ADDENDUM #1

Reference: Water Line Replacement – Fremont Indian State Park
Division of Parks and Recreation – Sevier County, Utah
DFCM Project No. 07302510

NAME: FREMONT WATERLINE REPLACEMENT PROJECT

PROJECT #P08FI00953 - DFCM #07302510

TYPICAL AIR RELEASE / VACUUM VALVE

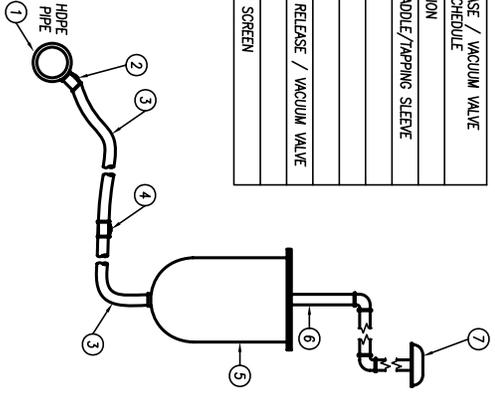
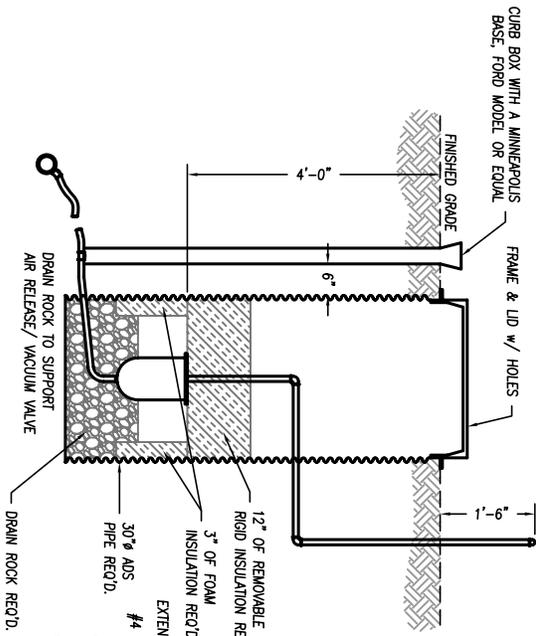
1. Sheet 3, of the drawings, has been changed to make both Vacuum Valve details match. The vent pipe has been lengthened and inserted a 90 to match the lower detail.

2. Instructions have been made to include a #14 mesh screen inside the vent cap (Air Vac Detail).
3. The note to the Typical 1 detail, that the outlet shall be covered with a #4 screen to be 12 to 24 inches above the original ground surface.
